Project Name:	Factory 52 - Market Hall - Innovation Hub	Submittal Code:	233423.00-PD-01	REV:	00
Document Set:	Bid/Construction				
KLH Project #:	22552.01-Bid	Received Date:	02/11/2022		
Section Name:	HVAC Power Ventilators				
Section Number:	233423.00				
Submitted By:	HGC Construction Co.				
Authored By:	Cincinnati Air Conditioning				
Client Name:	MSA Design

Submittal #233423-23A.26.1 - F52: Food Innovation Hub - HVAC Power Ventilators - SD 233423 - HVAC Power Ventilators

Architect: MSA Design
Engineer: KLH Engineering
HVAC: Cincinnati Air Conditioning
Item: Power Ventilators, PER BULLETIN #1 (EF #1 ONLY)
Spec. # 233423

Model: G-120-B
Direct Drive Centrifugal Roof Exhaust Fan

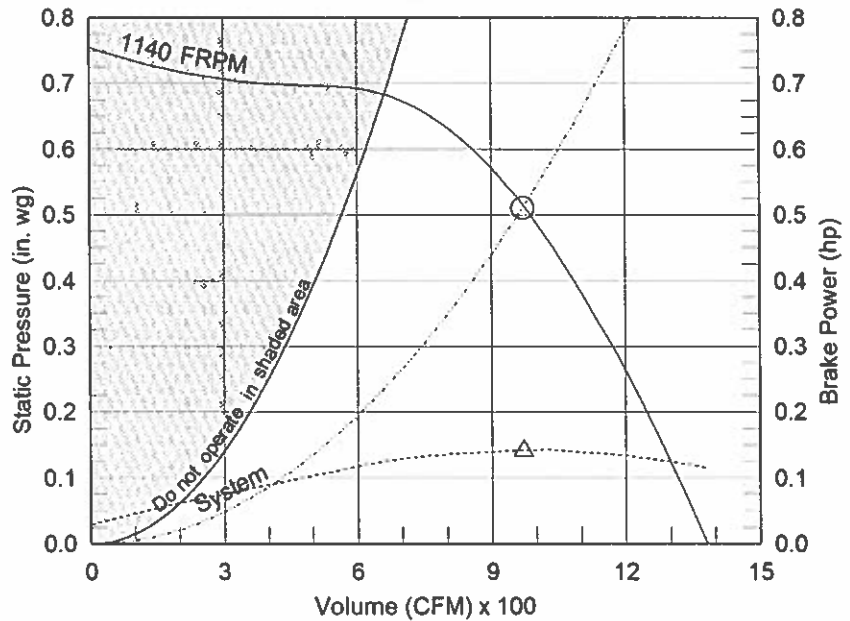
- 1.1 No exceptions to submitted Greenheck fan G-120-B.
- 1.2 No exceptions to accessories including VCD control damper and roof curb.
